## BECK NORTH UNIT 54 JSP16-36

Public hearing at the request of Dembs Development, Inc. for Special Land Use, Preliminary Site Plan, Woodland Permit, and Stormwater Management Plan approval. The subject parcel is located in Section 4 east of Nadlan Drive and north of West Road. It is approximately 5.02 acres and zoned I-1 (Light Industrial). The applicant is proposing to build a 67,000 square foot speculative building in the Beck North Corporate Park with associated site improvements.

# PLAN REVIEW CENTER REPORT

**EAST ELEVATION**

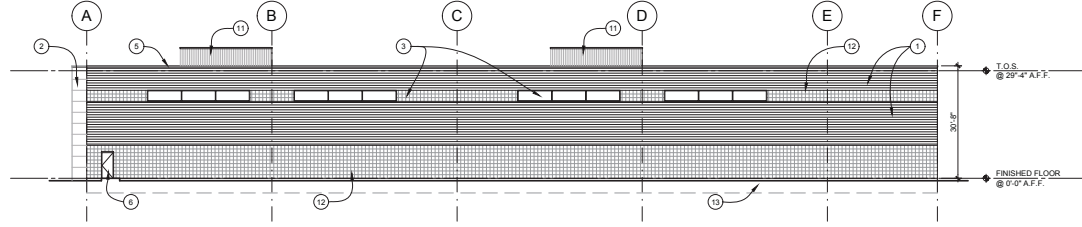
REVIEW	RESULT	DATE	COMMENTS
Planning	Approval recommended	2-23-17	<ul style="list-style-type: none"> <li>• <b>Special Land Use approval required</b></li> <li>• <b>ZBA variance for height that exceeds 25 ft. (29'4" proposed) when abutting residential</b></li> <li>• Items to be addressed on Final Site Plan submittal</li> </ul>
Engineering	Approval recommended	3-7-17	<ul style="list-style-type: none"> <li>• <b>DCS variance for not meeting minimum frontage of 300 feet required to allow more than one full service driveway entrance to the site</b></li> <li>• Items to be addressed on Final Site Plan submittal</li> </ul>
Landscaping	Approval recommended	8-21-17	<ul style="list-style-type: none"> <li>• <b>Lack of 10 - 15 ft. landscaped berm between industrial and residential not provided due to preservation of 50 ft. woodlands buffer along east property line and screening with masonry wall and additional evergreens – Staff supported</b></li> <li>• <b>Waiver for use of evergreen species for greater than 25% of perimeter parking lot trees – Staff supported</b></li> <li>• <b>Reduction of required subcanopy trees for industrial subdivision frontage due to lack of space (9 provided; 16 required) – Staff supported</b></li> <li>• Items to be addressed on Final Site Plan submittal</li> </ul>
